RANCHO SANTIAGO COMMUNITY COLLEGE DISTRICT

ADDENDUM NO. 01

Bid #1470 VAV Valves Replacements
at
District Operations Center

Project ID #2929

1.3 Pictures of Existing Float Control and 2" Clay Valve Equipment are Shown Below

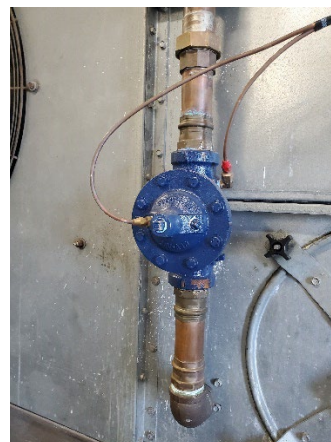
The District Office Center central plant (roof) has a cooling tower with an existing makeup water valve and level control which requires replacement.

The cooling tower provides cooling water to the chiller system. The mechanical devices have intermittently caused overflow to the mechanical room and are required to be replaced under this scope of work. The existing equipment consist of a makeup water level float control and the pneumatically actuated 2" clay valve. Both are located on the roof in the central plant mechanical equipment room.

The contractor is to provide all labor, materials, and equipment to replace the existing pneumatically actuated float control valve and 2” Clay valve with new electronic level control equipment.

- “Isolate”, disconnect and remove the existing float within the E-Z Float basin.
- Leave the EZ-Float basin intact for reuse and the addition of an electronic level sensor.
- Close and secure the ball valve makeup water line running to the Clay valve.
- Remove the 2” Clay valve.
- Return used equipment to the District Office representative.

DOC Cooling Tower Water Alarming and Level Control

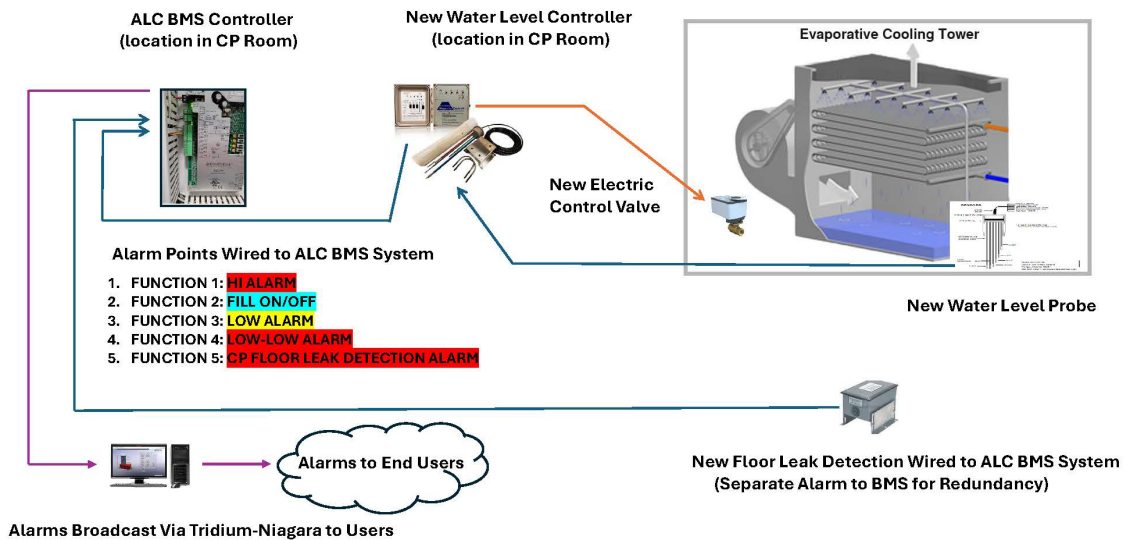
The pictorial Graphic below demonstrates the overall intent to install new equipment that must meet or exceed the following specifications:

- Furnish and install, one(1) new, 120 VAC Water Level Fill Control Instrument with the following features:
 - High, Low & Low-Low Alarms.
 - NEMA 4X control enclosure.

- Install new 2", two-way, Belimo makeup water control fill valve from the domestic water line into the point of cooling tower entry.
 - Actuator to be 24 VAC, 2 – Position, Open-Close, with a fail-safe position of CLOSED.

- Furnish and install in the existing EZ FLOAT container, one (1) new water level sensor probe to include the following features:
 - Minimum 50’, factory supplied sensor cabling. Contractor to order correct cable length.

- HIGH ALARM.
 - FILL ON/OFF.
 - LOW ALARM.
 - LOW-LOW ALARM.
- Sensor cabling to be in conduit installed to the new level controller.
- Furnish and install one (1) KELE WD-1B Floor level water leak detection sensor.
